The
Heritage
Practice

Pre-application Heritage Appraisal Addendum
Nos. 3-5 Bedford Row, London, WC1R 4BU

June 2024

Figure 1:
Proposed
fillet detail
to first and
second
floor front
windows

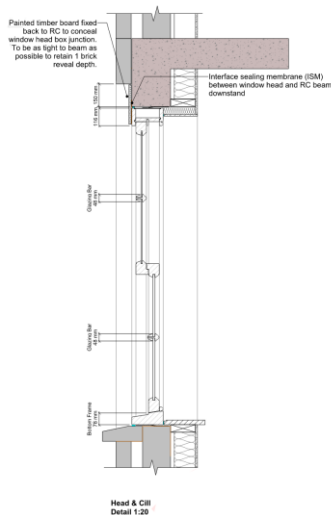
3.2 One change is proposed to the principal elevations on Bedford Row. The original consent allowed for the removal of the pelmets at the head of the first and second floor windows.

3.3 However, it has subsequently been discovered that an unknown consequence of the 1960s facsimile rebuild is the concrete structure cutting across the window heads at these levels. The proposed non-material amendment therefore seeks to retain a timber fillet detail above the head of the windows (figures 1-3).

3.4 The proposed change would maintain the appearance of the building from the existing (pre-approved scenario) and therefore would preserve or 'do no harm' from situation prior to works commencing on site. Arguably the subtle fillet detail would be an enhancement from the pelmet detail and go some way to improving the appearance.
